Charles W. Woodward High School, Mandatory Referral, MR2020022

Completed: 7/16/20

Figure 7: MCPS Proposed Site Plan

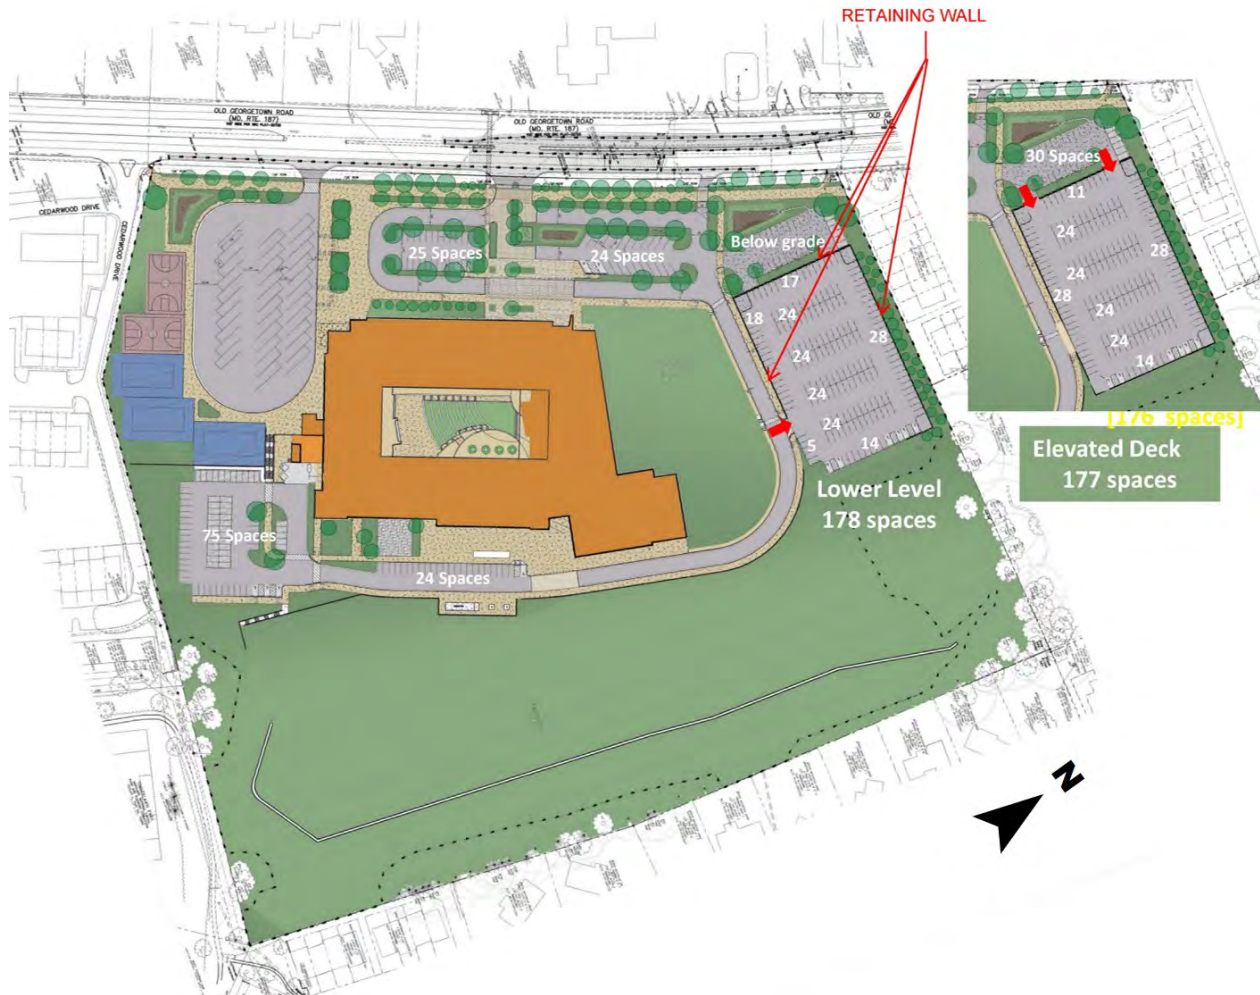
*Figure 6: Proposed School Building. Please note configuration of drive isles, parking, and plaza in front of the school do not reflect the latest submission (see Figure 5). This staff report recommends further design revisions to this area (see Figure 1).*

The Proposal for Phase 1 locates the new building on the western side of site. The bus loop is located to the south of the building and is accessed from MD 187/Old Georgetown Road. The loop is striped for buses and after hours use by cars.

Staff encourages the Applicant to revise the Proposal for consistency with Figure 1 to create a dedicated space for pedestrians and bicyclists to access the school from MD 187/Old Georgetown Road to improve safety and eliminate conflicts. Staff further encourages the Applicant to separate sidewalks from driveways by 6 feet or more in locations that are not anticipated to accommodate student drop-off.

**Figure 2: Phase 2 concept plans from April, 2020 submission**

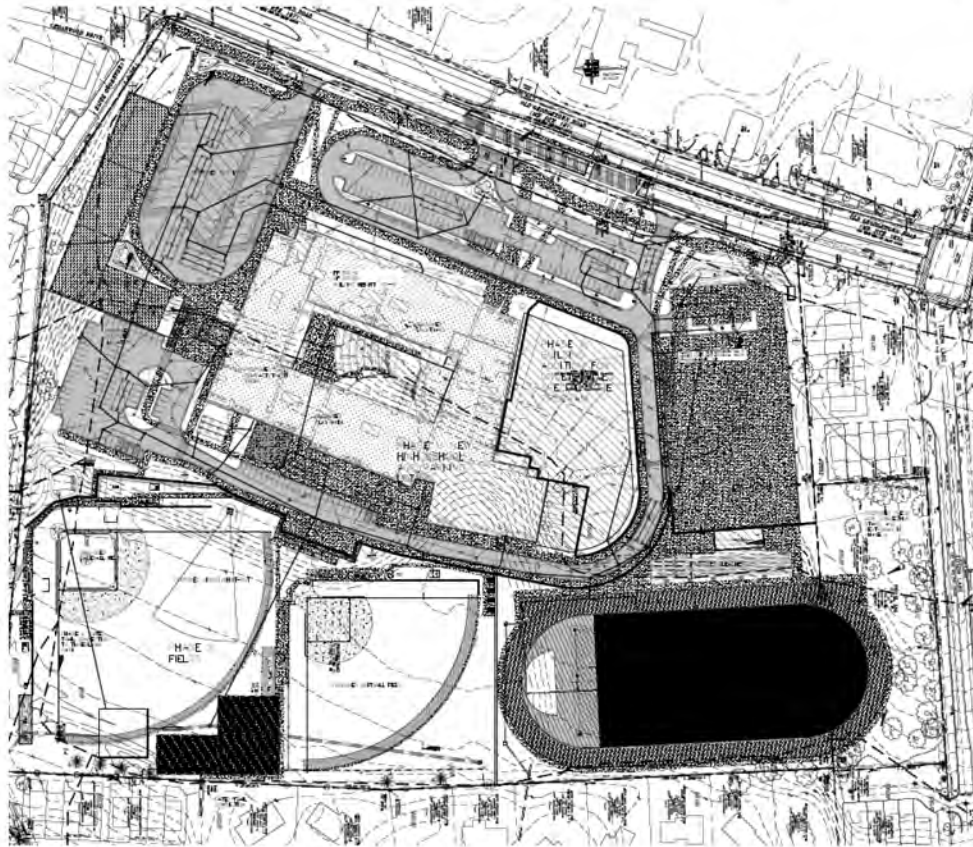
In their original April 2020 submission, MCPS proposed the use of Timberlawn Local Park for Physical Education classes during Phase I and the potential use for athletics in Phase II. The Phase II Concept plan submitted at that time showed only one rectangular field (versus four existing), - the stadium field and two diamond fields (see Figure 2). On June 9, 2020, Department of Parks staff sent a letter to MCPS outlining our concerns over that design's potential impacts to Timberlawn LP (Attachment 1.) Shortly after, MCPS informed Park and Planning staff of their intention to re-evaluate and resubmit their Mandatory Referral package. On July 2, 2020, MCPS sent a response letter indicating that they no longer intend to utilize Timberlawn Local Park for PE or athletics either in Phase I or Phase 2 stating, "MCPS currently has no intention of utilizing Timberlawn Local Park for Physical Education or athletics in either Phase I or Phase II. MCPS has quite a few high schools with similar field configurations as the final fields for Woodward HS which serve the athletics programs successfully" (Attachment 2.)

- Although the current mandatory referral only proposes use of the fields for PE classes during Phase I, the current Phase II plans show only one rectangular field - the stadium field. This seems to be an aberration compared to other high schools in Montgomery County – even those with similar acreage and similar enrollment. The absence of another rectangular field in these plans raises the question of whether MCPS intends to use the Timberlawn fields for athletics when Woodward High School reopens in Phase II. The use of these fields for such a heavy and potentially exclusive use by the school for student athletics will have to be approved by the Planning Board. In this role of approving “non-park use of parkland”, the Planning Board decision is not advisory in nature. Because that decision may have significant impacts on the design of the school, this relationship and potential agreement between the school and Montgomery Parks needs to be codified in the mandatory referral and presented concurrently.
